AMENDMENT OF PLAN UNDER SECTION 12A OF THE TOWN PLANNING ORDINANCE (CAP.131)

Planning Application No. Y/ST/48 under Section 12A of the Town Planning Ordinance

Planning Application No. Y/ST/48

Figure 4.2 Pedestrian Management Plan (Extracted from Figure 3.1 of Traffic Management Plan)

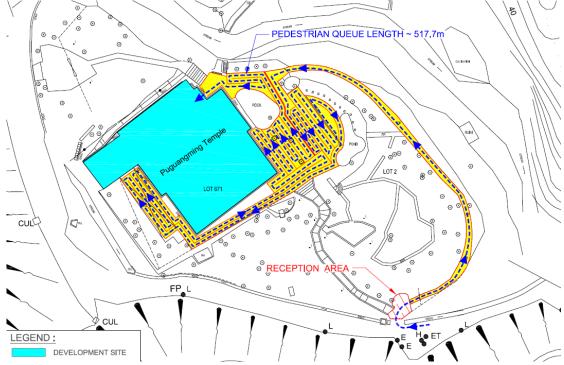
RtoC (f) and Para. 3.3.2 (ii) – It is noted that the proposed holding area shown in Figure 3.1 is adjusted to locate within the lot boundary of the site. However, it is questionable why the area of the adjusted holding area would remain unchanged. Please mark the dimensions of the proposed holding area on Figure 3.1 and demonstrate, with photos, the whole holding area could be used for holding visitors. Please also review if the area of pedestrian accesses within the proposed holding area should be deducted from the calculation. Besides, the pedestrian route shown in Figure 3.1 is different from that shown in Drawing AR 1.
